Proposal No. 608051-132406

ADDENDUM NO. 5

**Federal Aid Project No. STP/CMQ/HSI-0034(030)X
Reconstruction on Route 38 (Main Street), from Route 62 to the Woburn C.L.**

Questions and Responses

DRAINAGE PLANS - 13

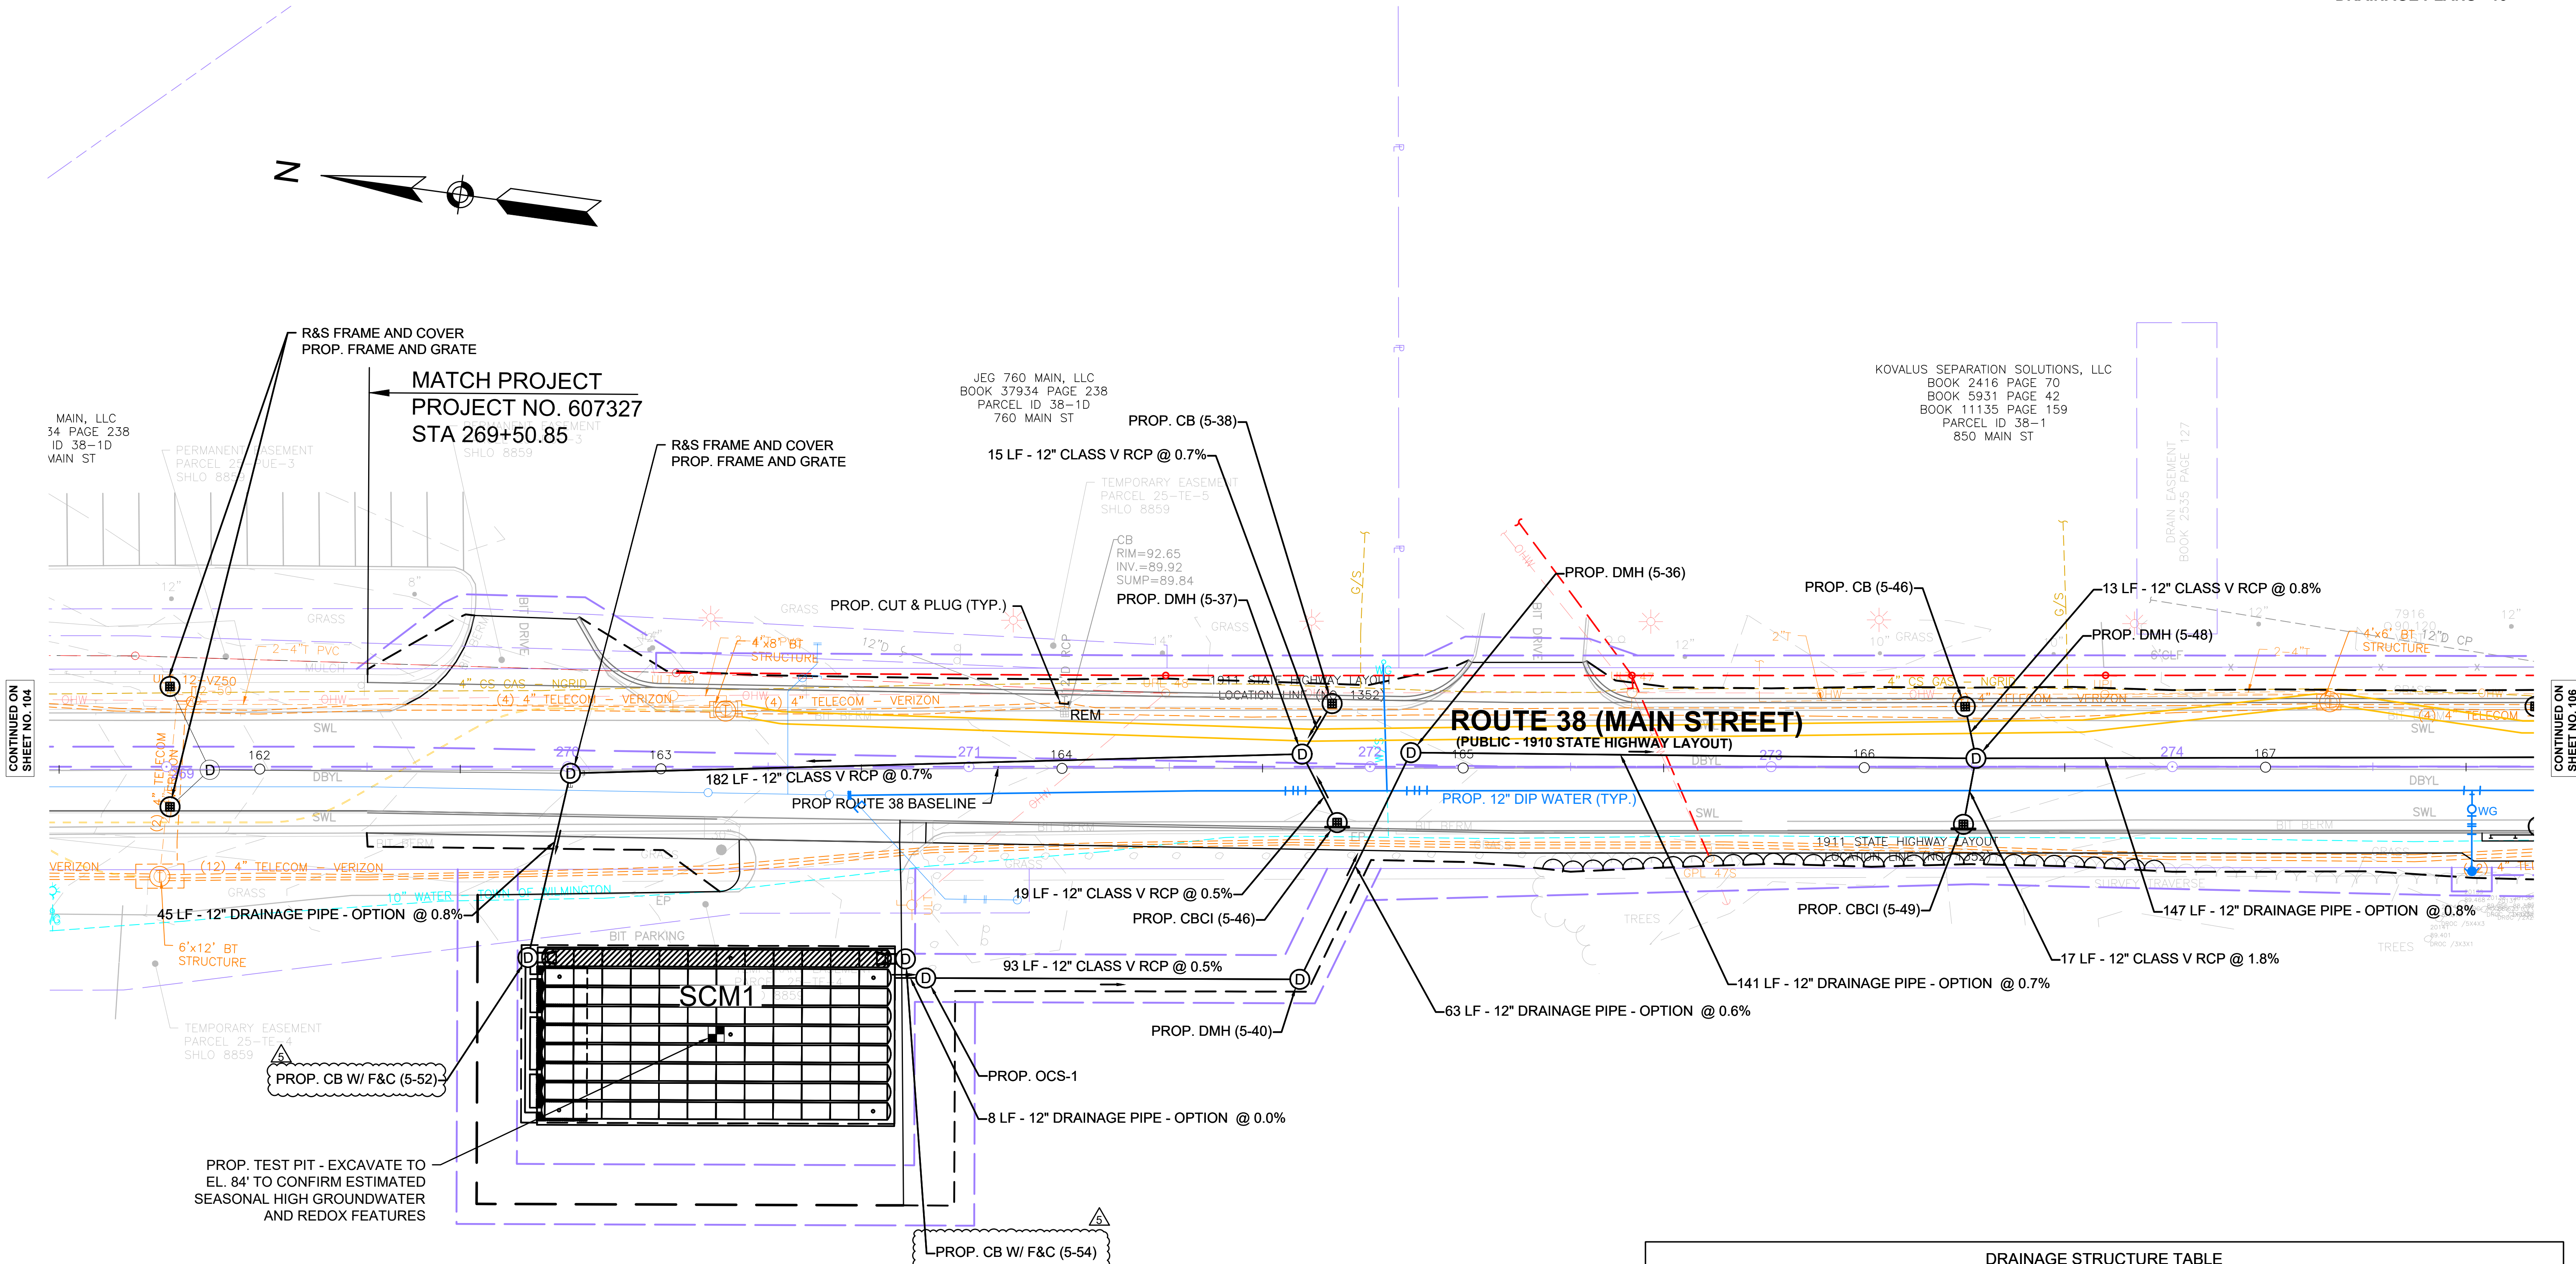
Question 45) On plan sheet 105 of 420, there is a callout of "DMH 5-52 and DMH 5-54" that do not show up on the drainage table. Are these DMH's required?

Question 52) Proposed DMH (5-52) and (5-54) on Sheet 105 of 320 do not appear on the “Drainage Structure Table”; also Proposed DMH (7-31) and (7-35) on Sheet 112 of 420 do not appear on the “Drainage Structure Table”. What are the elevations for these DMHs and under what Bid Item are they paid?

Response 45) DMH 5-52 and DMH 5-54 have been revised to CB W/ F&C 5-52 and CB W/ F&C 5-54 and added to the drainage table on Sheet 105 as part of this Addendum. Refer to the SC-740 Isolator Row Plus Detail detail on Sheet 141 for more information.

TYPICAL PIPE TRENCH
NOT TO SCALE

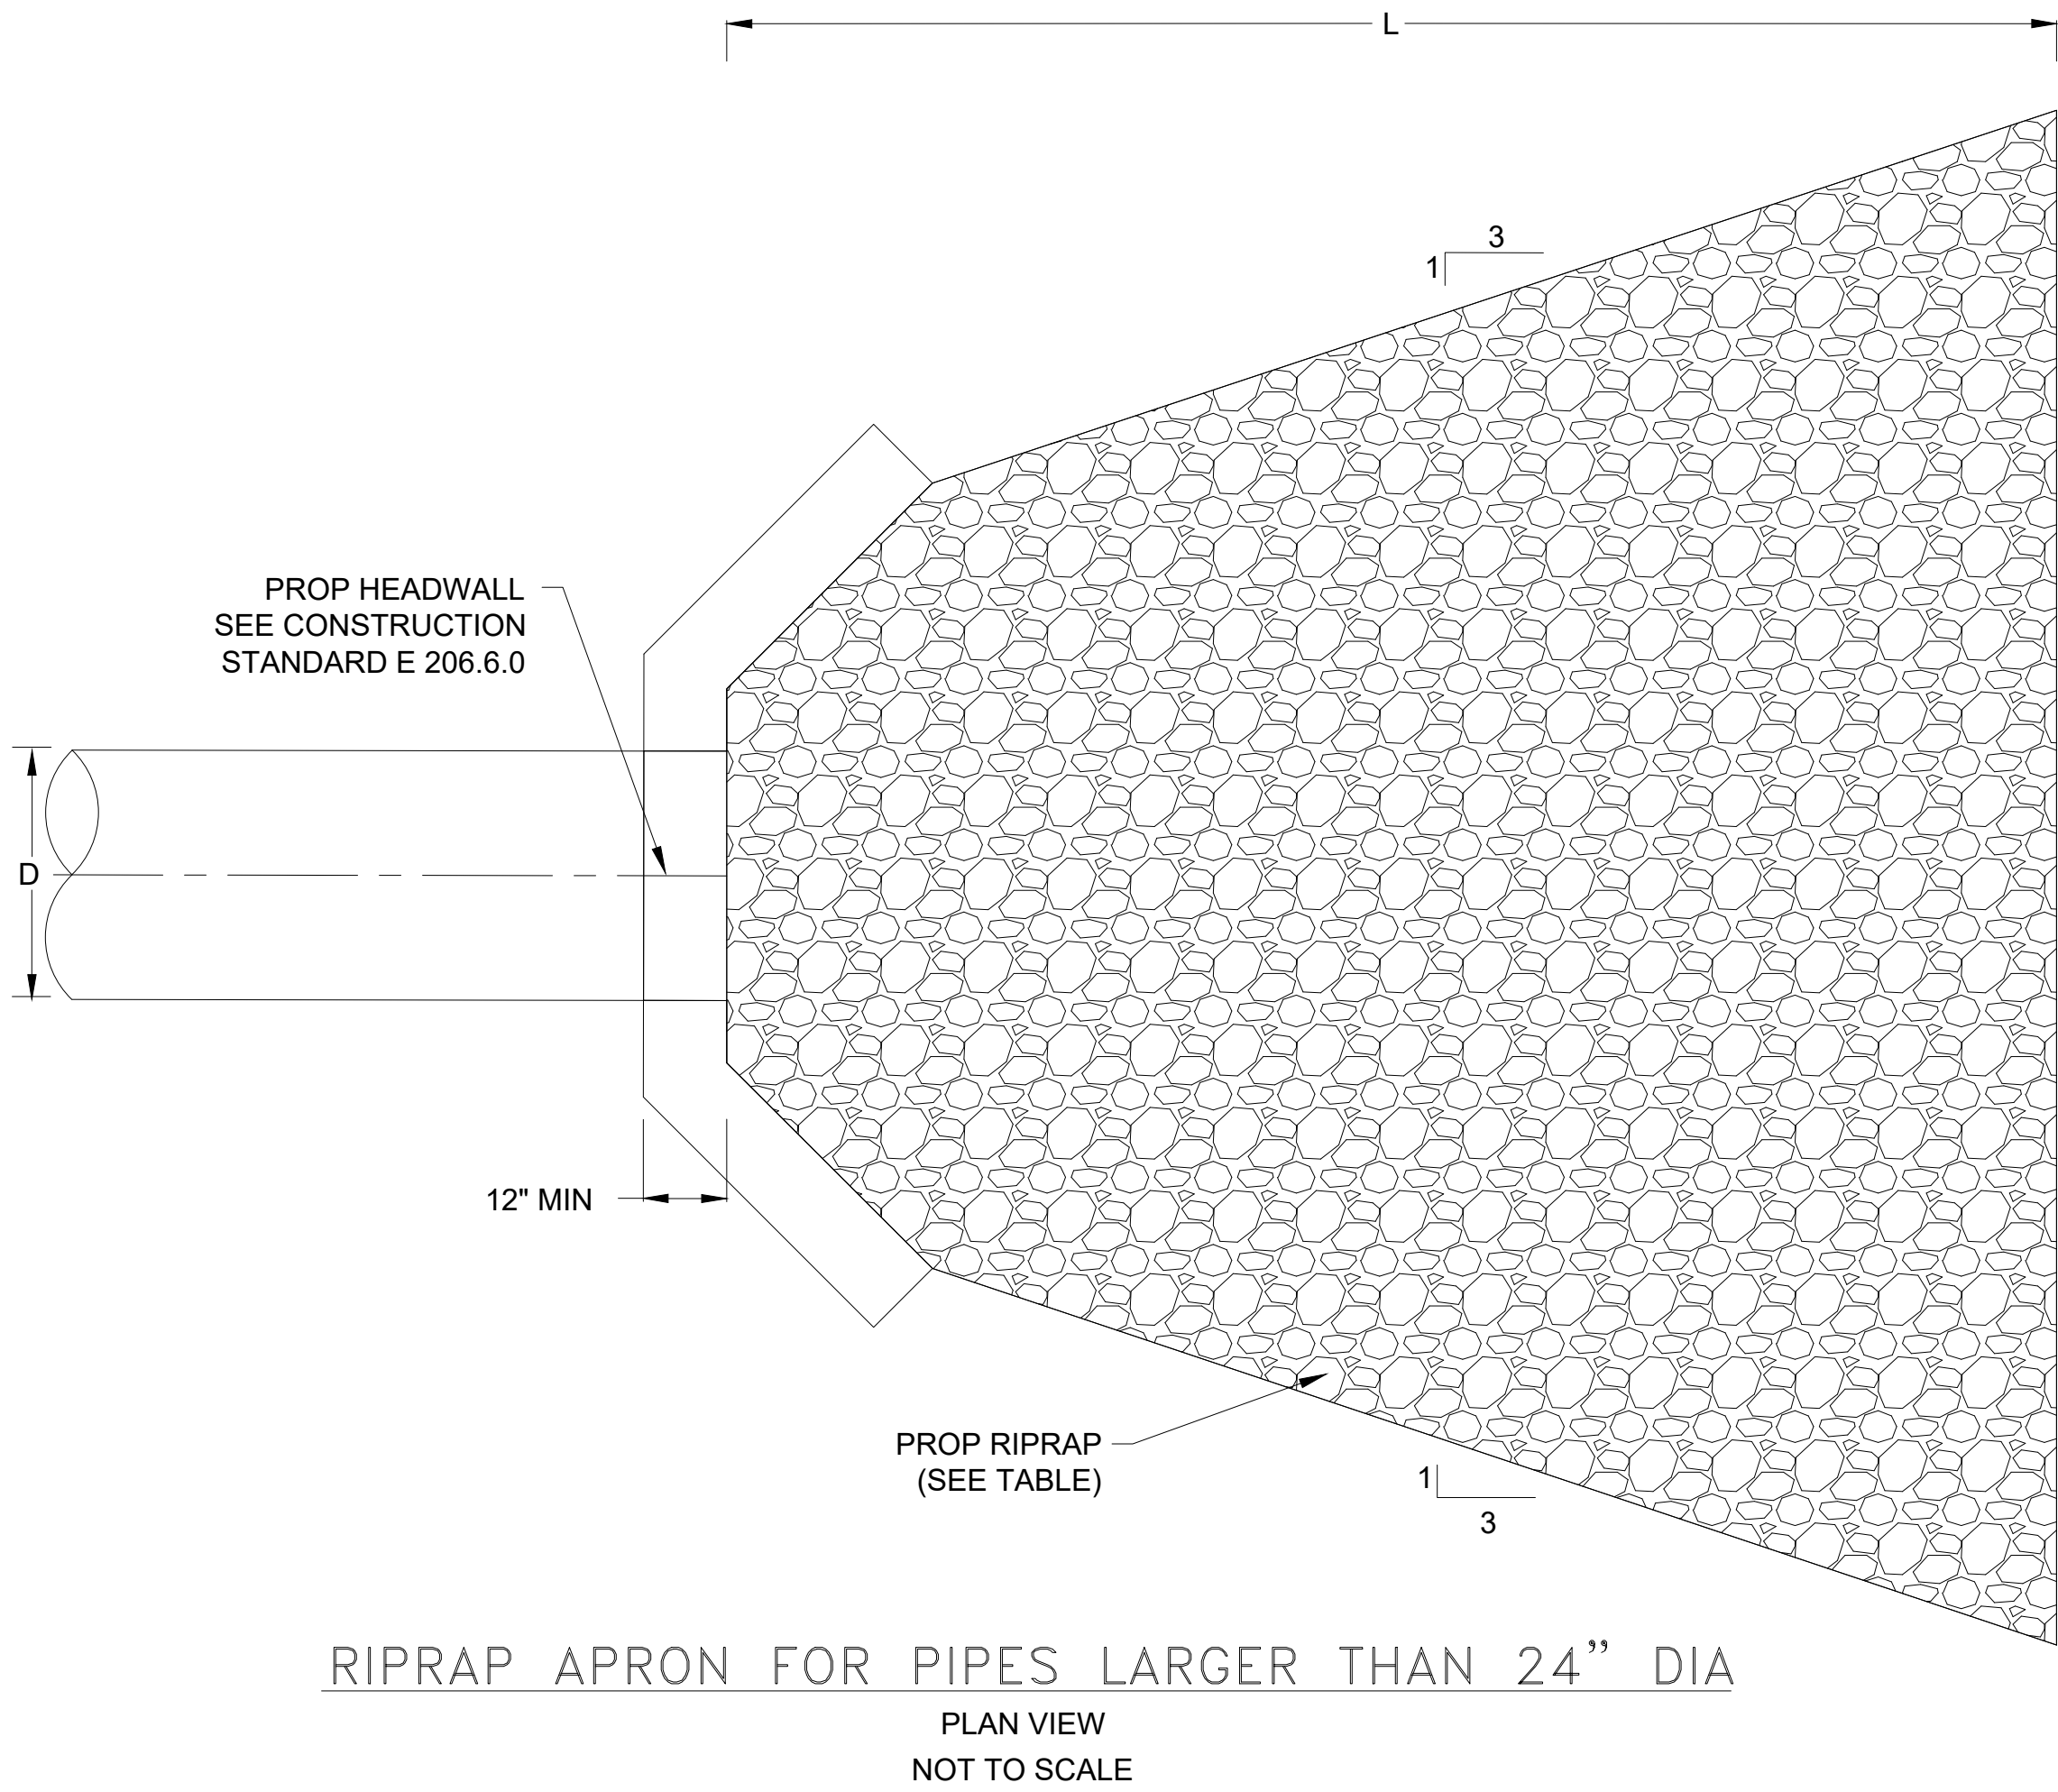
Question 41) The typical pipe trench detail on Sheet 225 of the plans calls for ¾" diameter crushed stone pipe bedding. Please confirm this crushed stone will be paid under Item 156 – Crushed Stone.

Response 41) Crushed stone pipe bedding will be paid under Item 156 Crushed Stone.

DRAINAGE & UTILITY DETAILS - 9

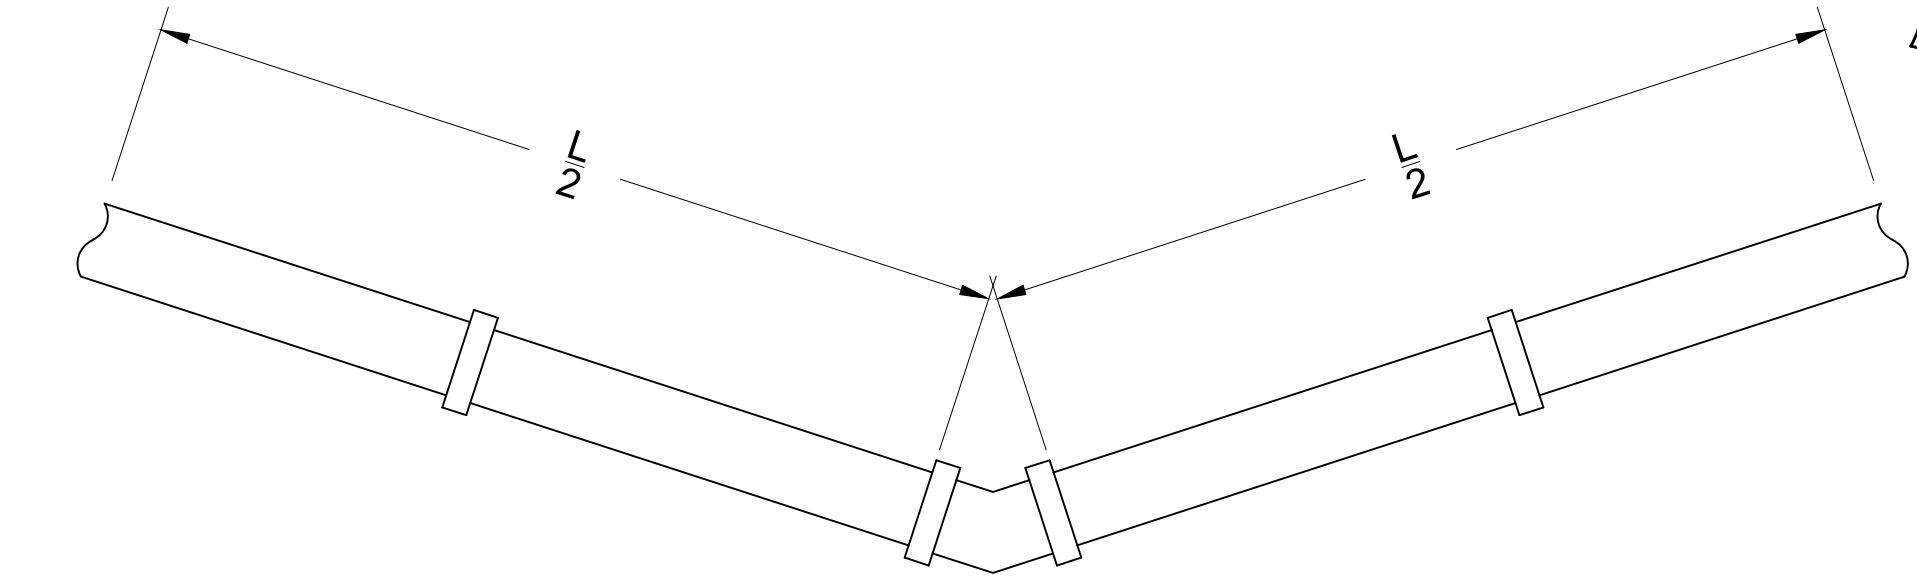
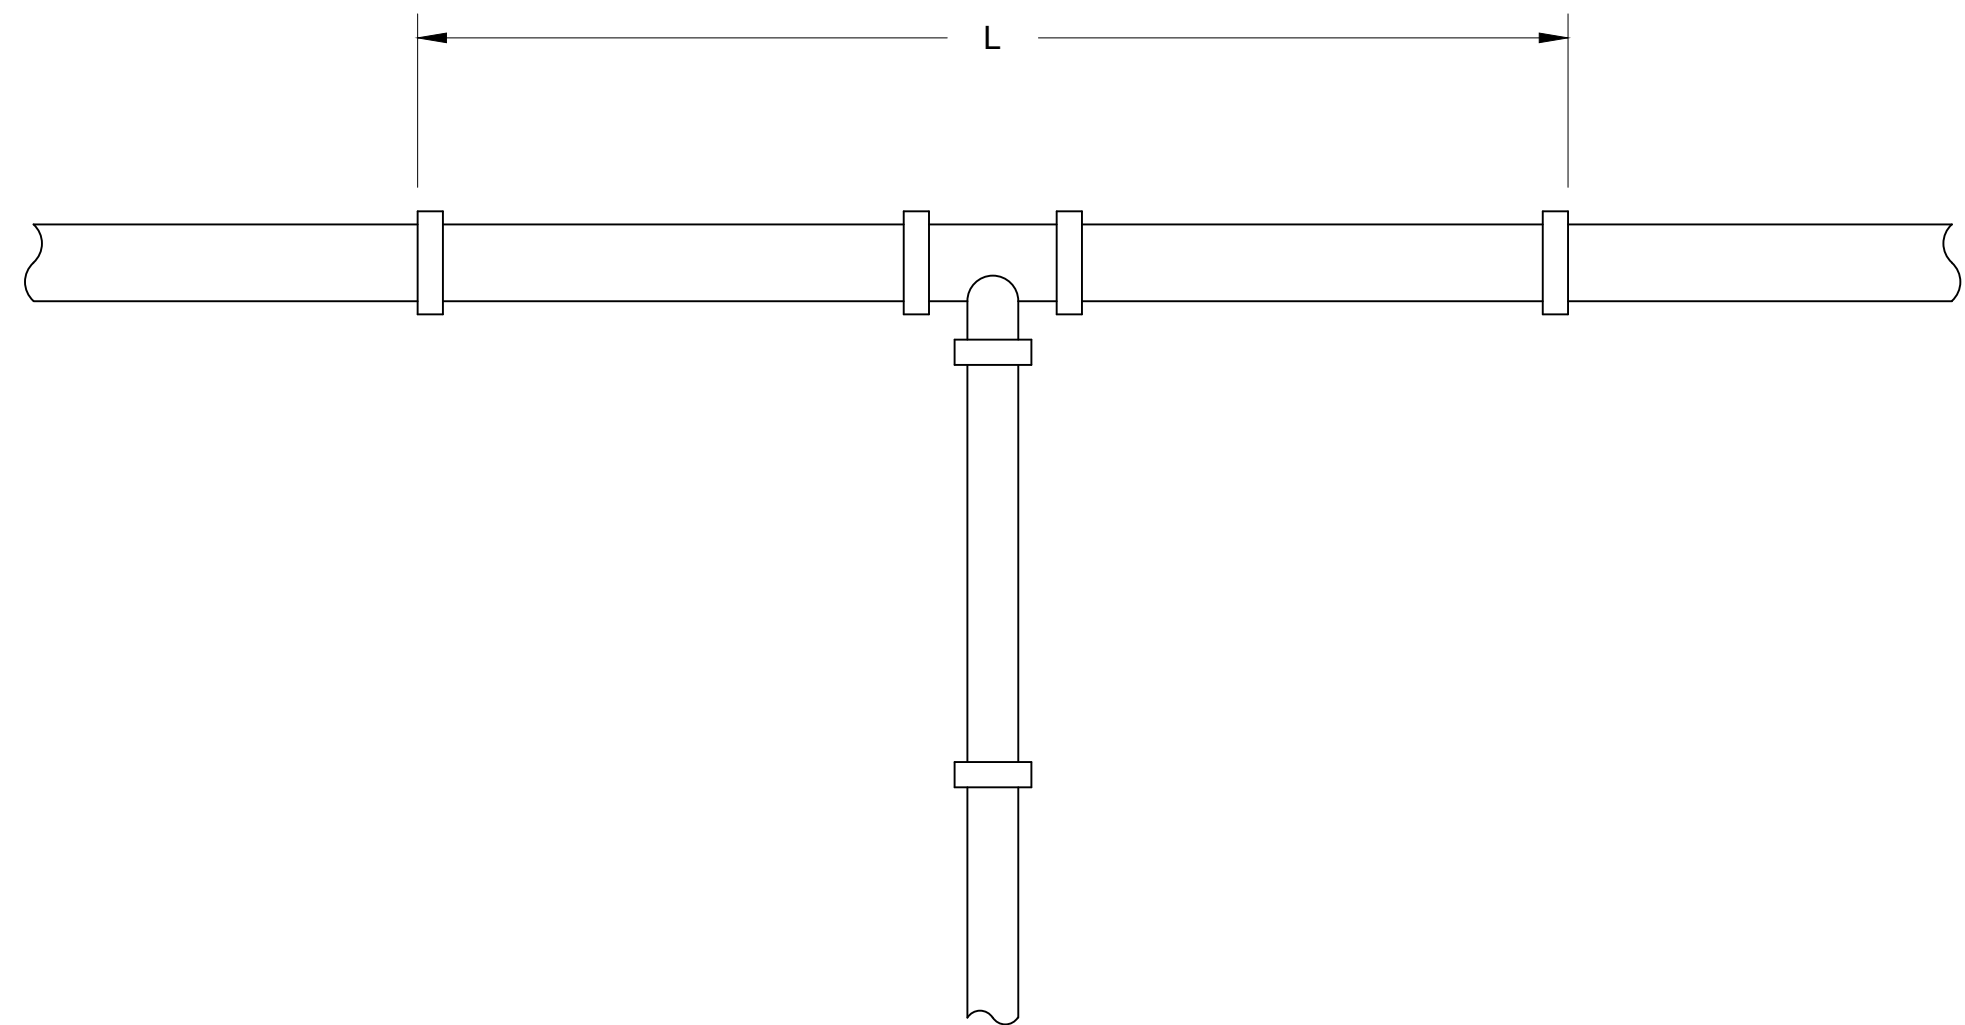
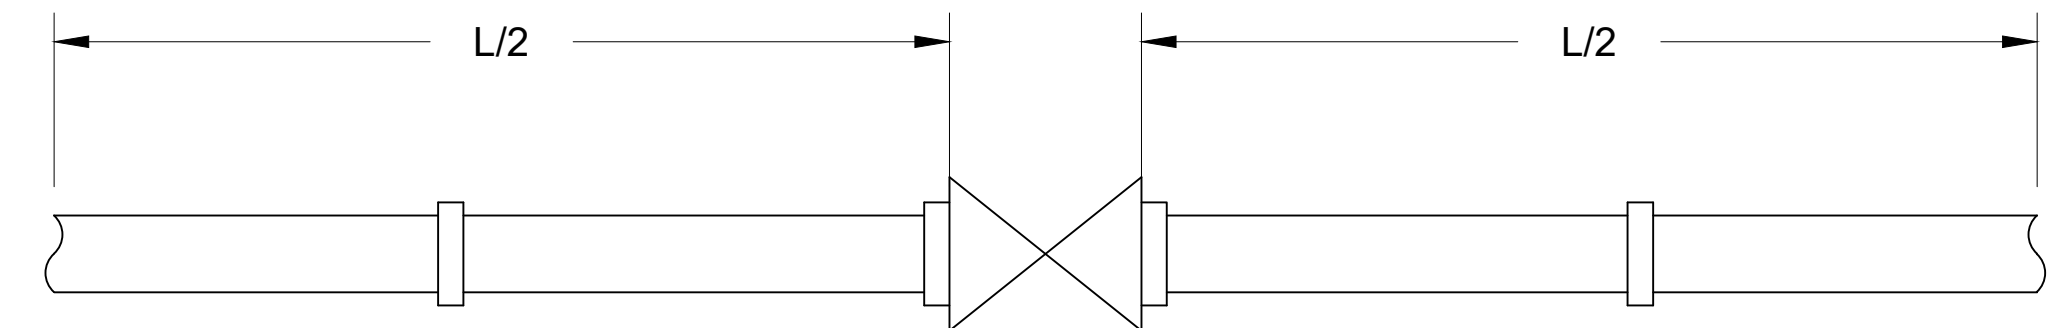
Question 7) Please confirm measurement and locations for bid item 303.12-12 Inch Ductile Iron Water Pipe (Mechanical Joint).

Response 7) See Plans Sheet 142 and Proposal page B00420- 12. Detail and measurements have been added to Sheet 142 – Drainage & Utility Details 9. 12 Inch Ductile Iron Water Pipe (Mechanical Joint) will be installed at all fittings and gate valves per the detail.
